Bristol City Council – Strategic Partnership

Barton House Structural and Structural Fire Review

| 19 February 2024

Figure 5 Observations of hollow core floor slab construction [excerpt from second Ridge report]

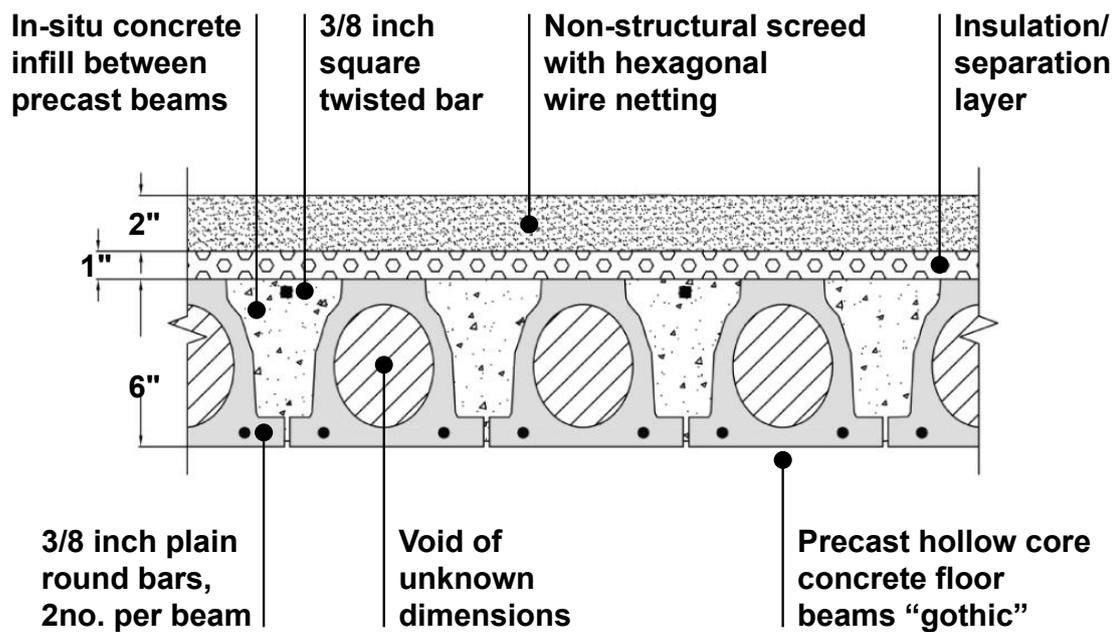
The original drawings specified 1/2" (13mm) cover to slab reinforcement. Our observations from the site survey carried out indicates that the bottom concrete cover to the reinforcement varied from 10mm -15 mm; this aligns with Ridge's reported observations their second report.

A 2D thermal response analysis of the floor slabs was conducted to determine the temperature affected depth of concrete and bottom reinforcement. Heating was applied to the underside of the slab and an ambient temperature condition to the top surface. The analysis was conducted based on a depth of cover range of 10-15mm consistent with the site survey findings.

A structural analysis of the slab acting as a simply supported floor was then performed. This established a likely fire resistance period of 55-70 mins, accounting for the measured variation in concrete cover.

Due to the uncertainty around the material performance of the existing plaster finish we have not included its thickness or an equivalent thickness as per BR128 guidance in our calculation of fire resistance above (this Section 4.6.2).

In terms of the potential significance of the plaster, if it could be established that the material present was for example a gypsum plaster with appropriate key and bond, the plaster finish could be considered to provide an additional ~6mm of cover to the concrete reinforcement. This would increase the estimate of fire resistance of the floor slabs from 55-70min to 70 - 85min.

Figure 6 Observed construction of internal cross wall [excerpt from second Ridge report]

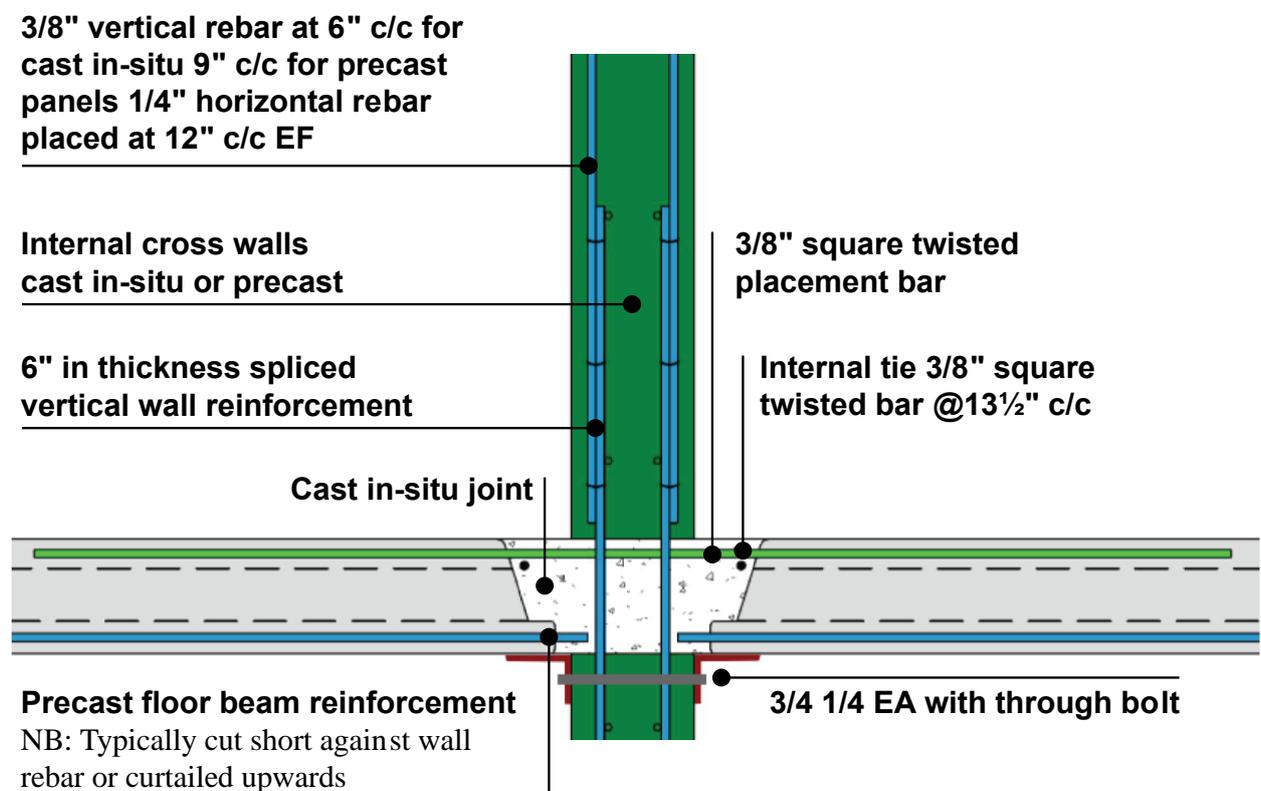
The original drawings specify cover to steel reinforcement above ground to be 1" (~25mm); therefore, indicating an intent to provide ~25mm of cover to the steel reinforcement in cross walls. Arup observed surveys of the cross walls and measurements 25-35mm concrete cover. In some locations measurements as low as 5mm were observed; in these locations a 40mm thick shotcrete layer to affected area was observed. This aligns with Ridge's site survey information as reported in their second report.

The additional 40mm of shotcrete increases low cover from 5mm to 45mm. Therefore, the minimum cover to cross wall steel reinforcement is taken as 25mm.

Steel shelf angles are evident in Figure 6. The original structural drawings indicate that these were likely to be temporary supports during the original construction; it is Arup's understanding that these are not relied upon for slab support in the permanent case. These shelf angles have therefore not been included in our assessment.

A structural analysis of the strength and stability of the wall was performed. This established a likely fire resistance period of 86-120 mins, for the range depending on whether the exposure is from either two sides or one side respectively.

Figure 7 Observed construction of external flank wall detail (left) and as intended from record drawings (right) [excerpt from second Ridge report]

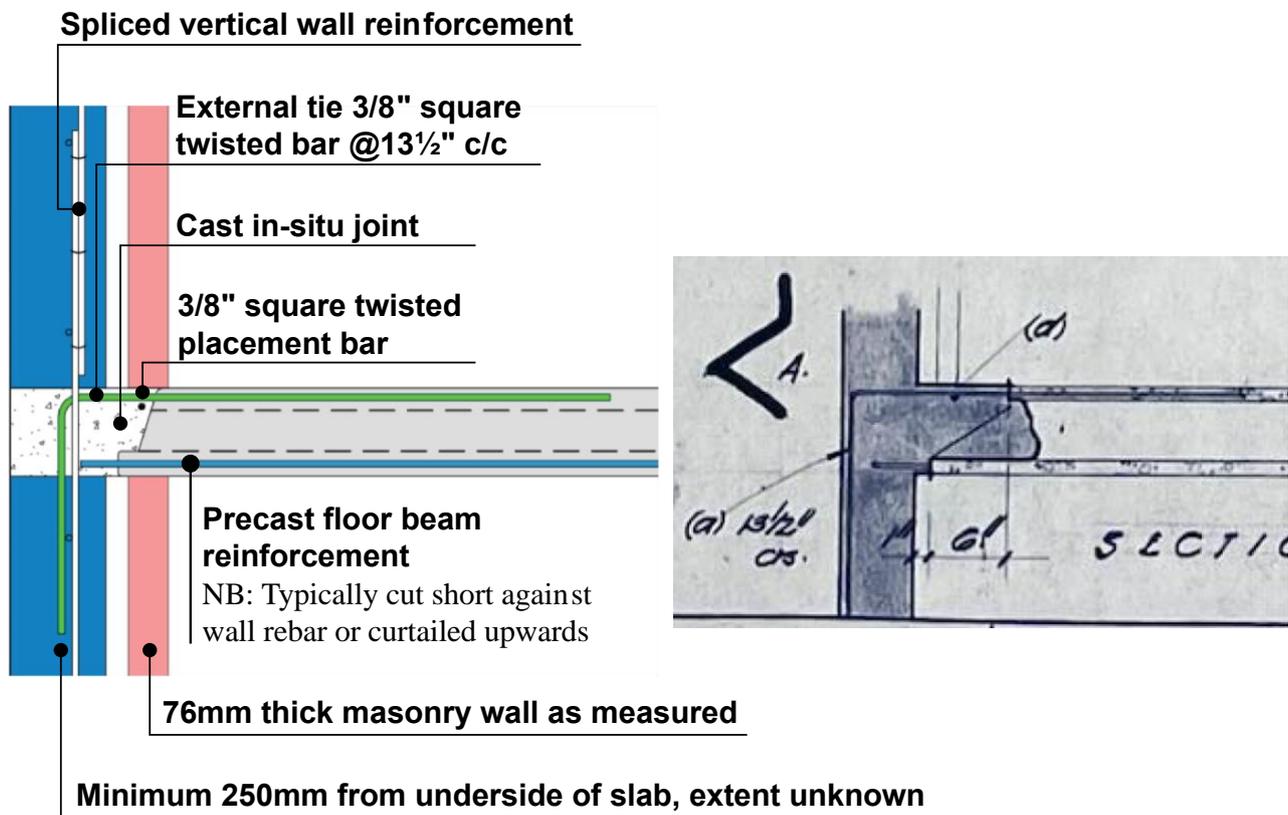
The original drawings specify cover to steel reinforcement above ground to be 1” (~25mm); therefore, it is believed the original intent was to provide ~25mm of cover to the steel reinforcement in flank walls. Typical cover measurements exceeded the 25mm intent in the record drawings. By exception some locations of low cover were observed (as described for internal cross walls); in these instances, a 40mm shotcrete layer was observed on the inner face of the flank wall.

In our analysis a minimum cover to flank wall steel reinforcement is taken as 25mm.

A lightweight blockwork wall was observed in front of the flank walls; these are present for each flank wall surveyed and appear on original drawings. Ridge describe the thickness of this blockwork wall as 76mm (3”) in the second Ridge Report which aligns with the record drawings. The presence of this wall provides additional protection to the flank wall in the event of a fire; this has been included in our assessment.

The 2D thermal response analysis of the external flank wall was conducted for observed minimum cover of 25mm and included the presence of the lightweight blockwork. Our analysis established that the thickness of this construction in front of the flank wall provides sufficient insulation to prevent any significant strength loss of the steel reinforcement or concrete for the duration of the applied 120-minute heat exposure.

Therefore, the external flank walls (including the adjacent blockwork construction) can be considered to achieve a period of fire resistance in excess of 120 minutes.

Figure 8 Comparison of means of escape provisions with recommendations of CP3 IV 1962

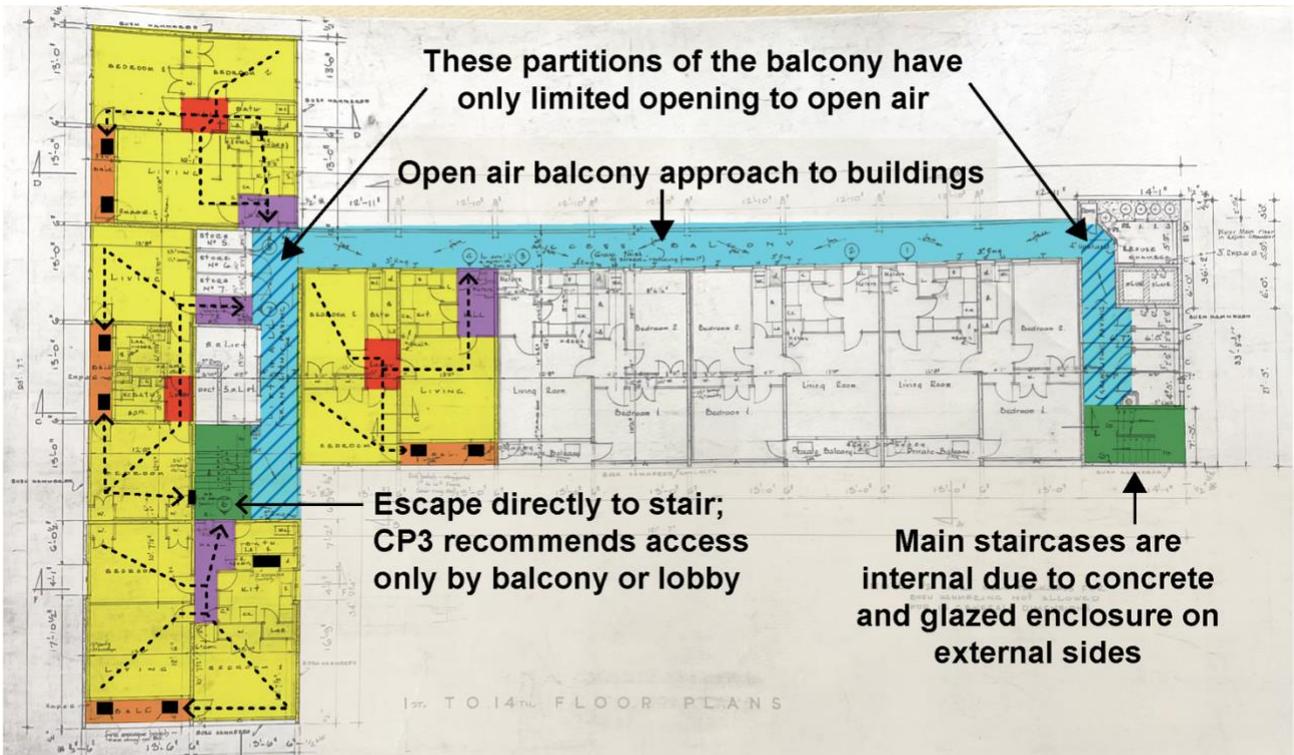
We have compared the means of escape arrangements at Barton House with those set out in CP3 Chapter IV Part 1 (1962). The features of Barton House analysed in this comparison are illustrated in Figure 8. The original arrangement of Barton House aligns with CP3 Chapter IV Part 1 (1962) as follows:

- a) **Stage I (internal planning of flats):** Flats were planned with a private entrance hall with no fire risk. Bedrooms are accessed through the lounge; these bedrooms are separated from the lounge by an inner hall and an alternative dwelling exit by means of a vertical fire hatch located in the residential balconies. In flats where bedrooms do not have a window to the balcony approach⁷ to the escape staircases further escape hatches were planned providing an alternative means of reaching the balcony approach or a main staircase. The provision of the inner hall and alternative exits align with Clause 206 a.ii of CP3 IV 1962 which stated “*if necessary to pass from one bedroom to another in order to reach the alternative, the bedrooms should be connected by.... Inner hall which is cut off by a self-closing door from any other part of the flat*”. Although it should be noted that CP3 IV 1962 does not specifically describe the use of fire hatches.

- b) **Stage II (escape from flats to main staircases):** Escape from the common areas of Barton House is by the external balcony approach to one of two remote staircases. As escape from each dwelling is by the balcony approach to one of two stairs the design aligns with Clause 207 a.ii of CP3 IV 1962 which stated “*alternative exits from each dwelling are considered to be necessary. A balcony on one side leading to main staircases at opposite ends will provide two such exits.*”

- c) **Stage III (main staircases):** The main staircases do not align with the recommendations as CP3 IV 1962 (Clause 208, 306) recommends they are enclosed throughout their height and having fire resistance of not less than one hour. The staircases in Barton House are not enclosed or separated from balconies by fire resisting construction throughout their height. Nor do they appear to be external stairs as glazing is present to both staircases.
